ARCHITECTURAL REVIEW BOARD MEETING
CITY HALL, 385 SOUTH GOLIAD STREET, ROCKWALL, TEXAS
JULY 28, 2026 IN THE CITY COUNCIL CONFERENCE ROOM AT 5:00 PM

PROJECT COMMENTS

PROJECT NUMBER: SP2026-014
PROJECT NAME: Site Plan for 5133 S FM 549
SITE ADDRESS/LOCATIONS: 5133 South Farm to Market 549, Rockwall, TX, 75032

PLANNING AND ZONING COMMISSION MEMORANDUM

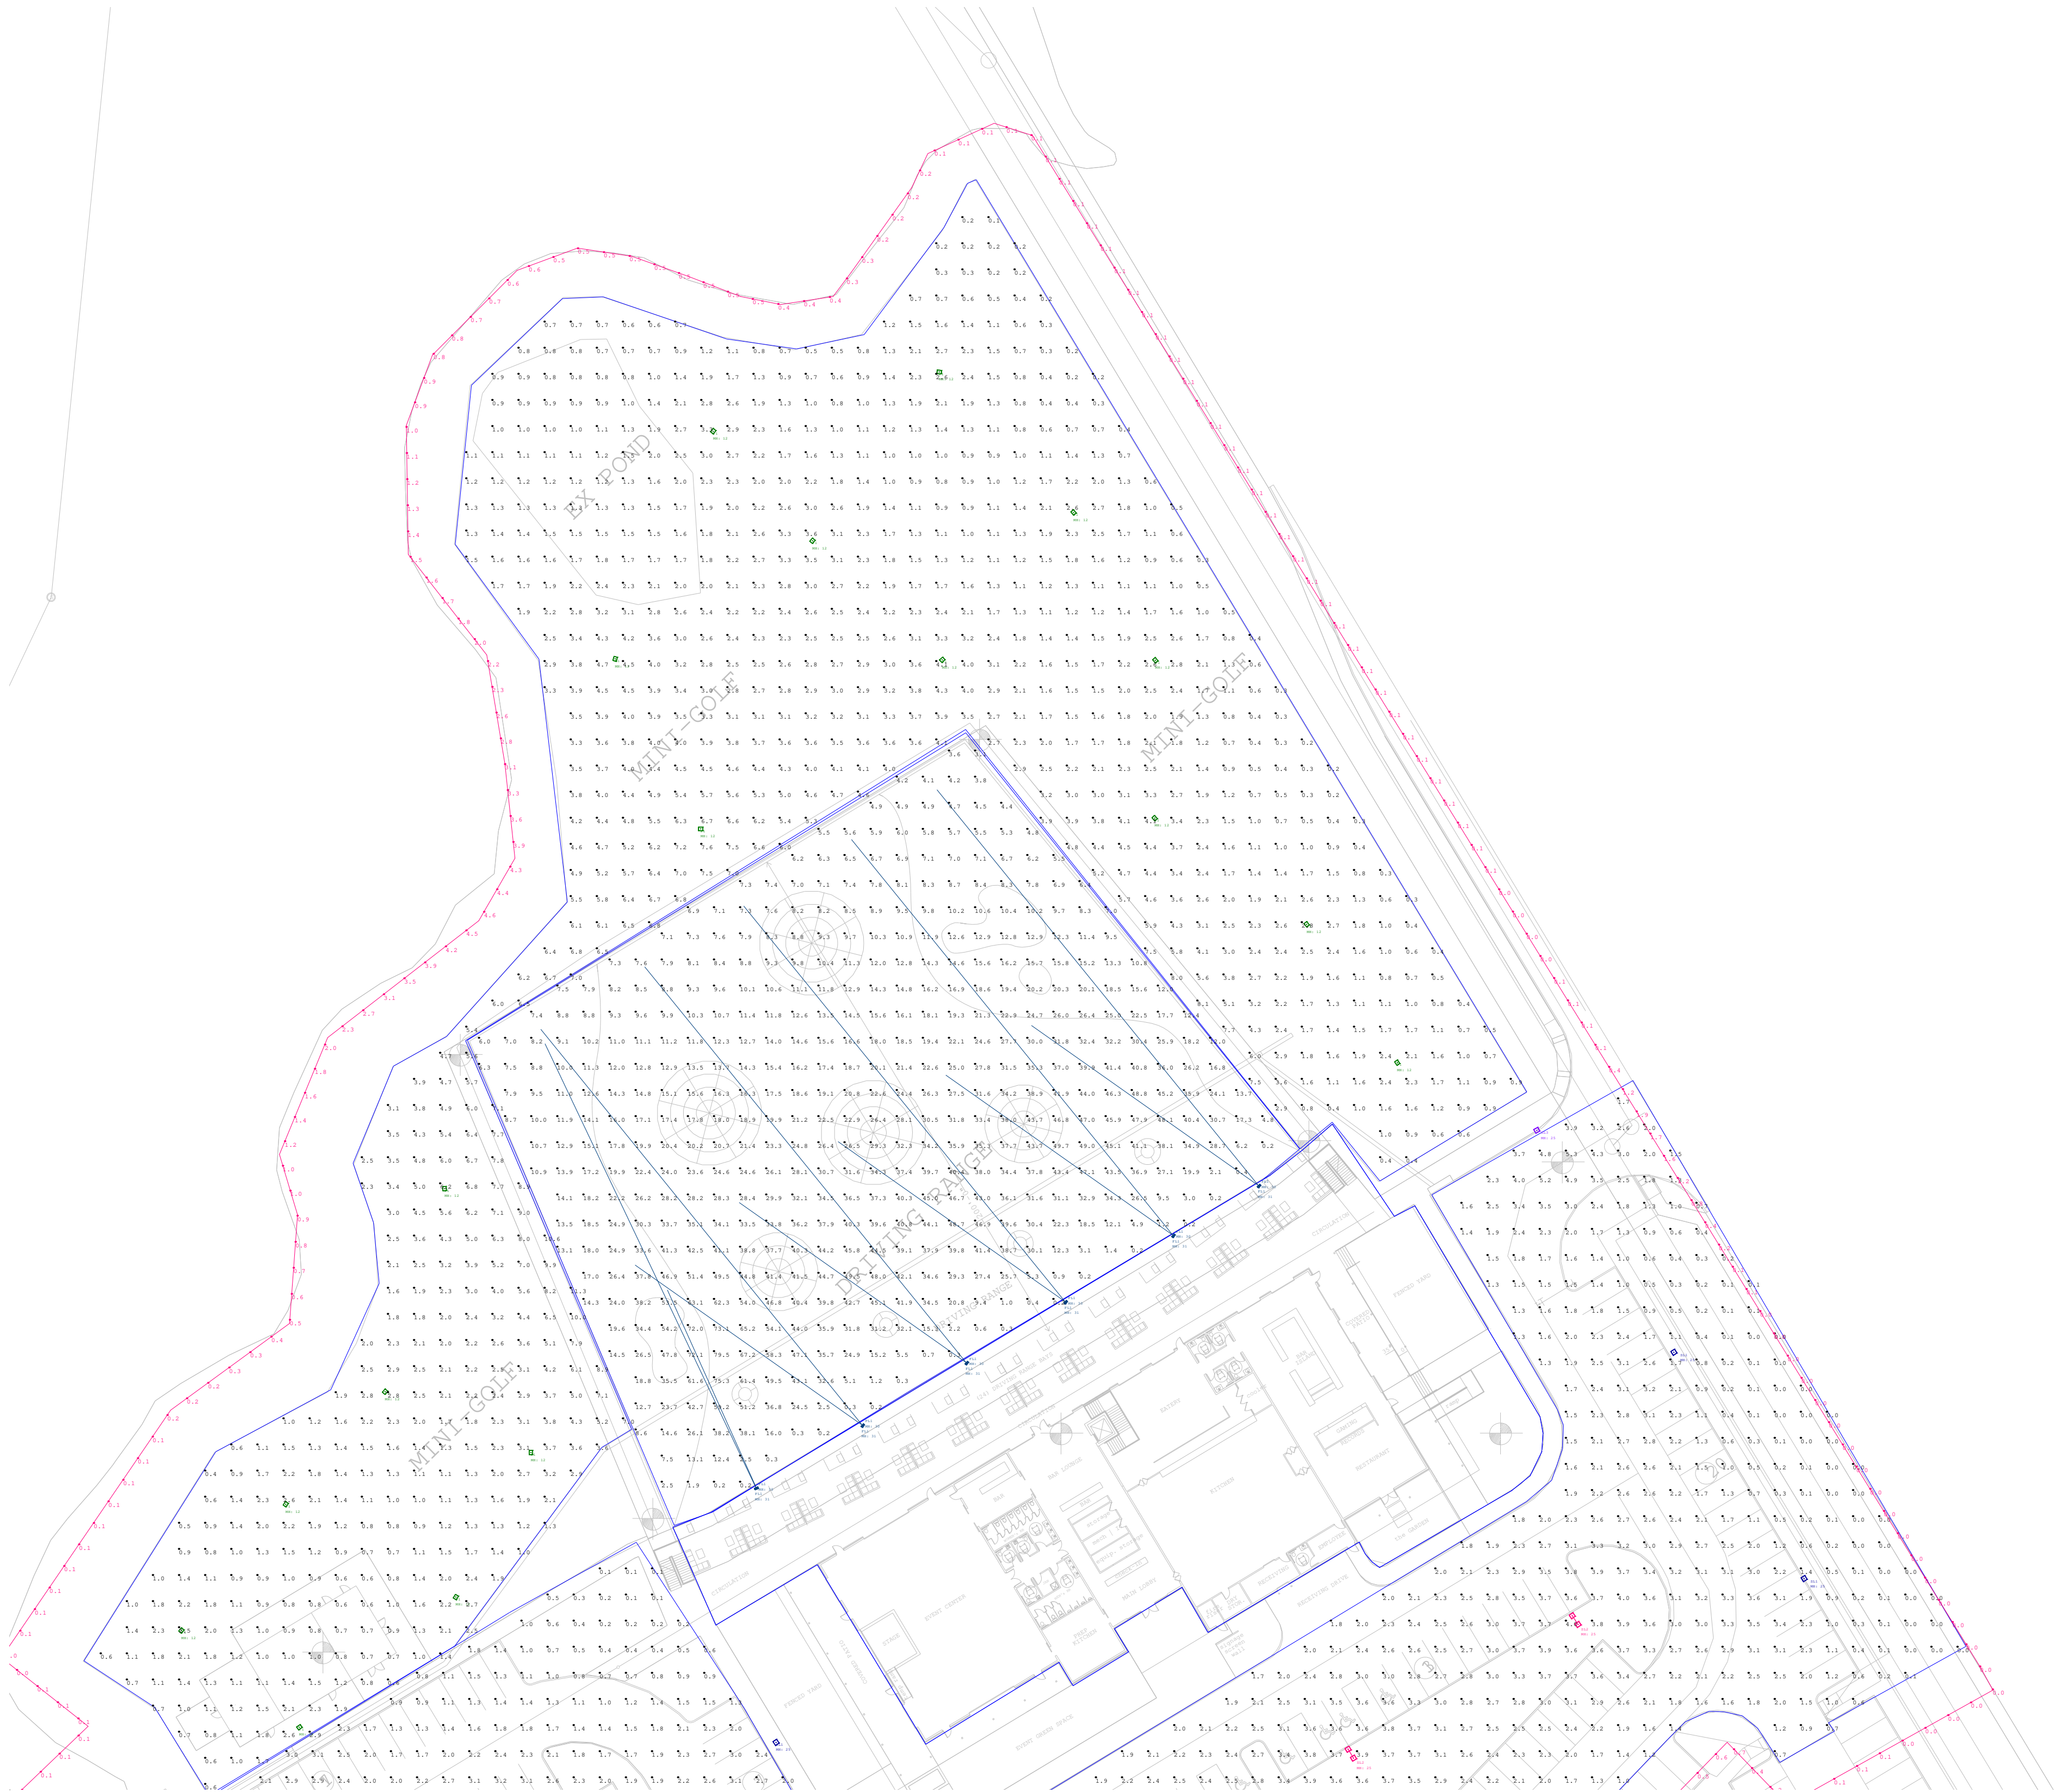
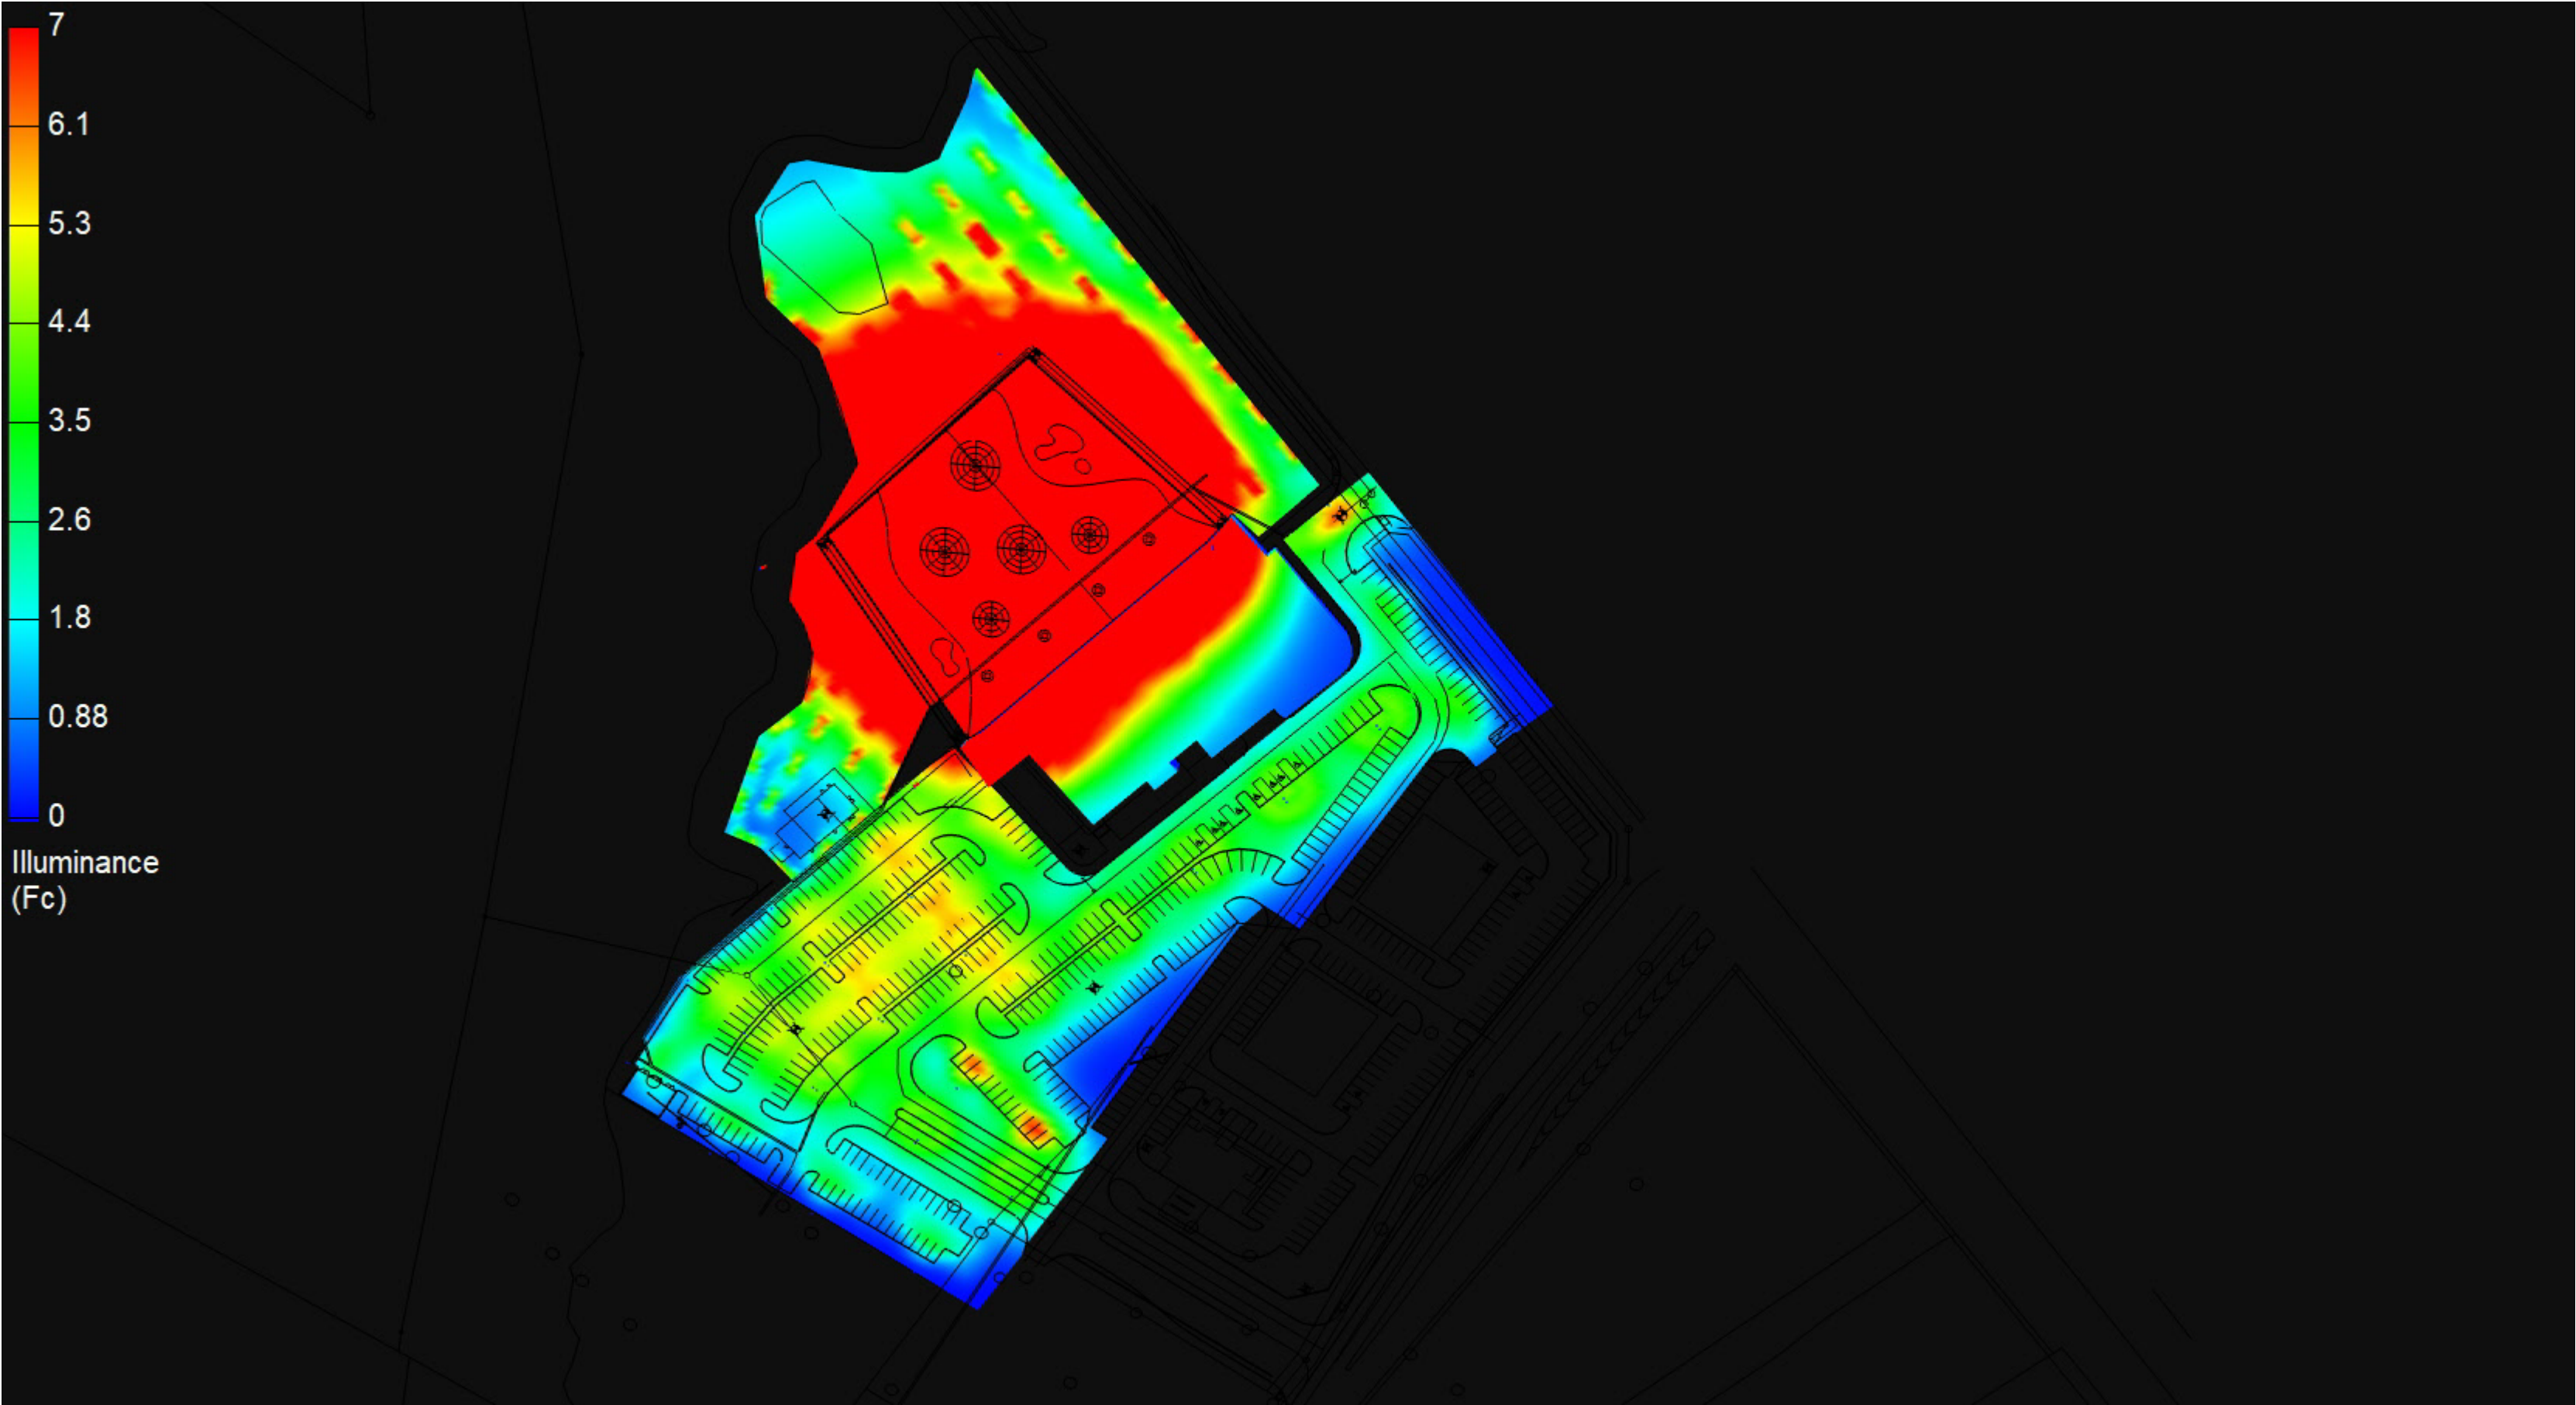
- (1) Provide the same site data information required in Section 2.1 Site Plan: Miscellaneous and Density and Dimensional Requirements of this checklist. (See Sec. 2.1 of the checklist)
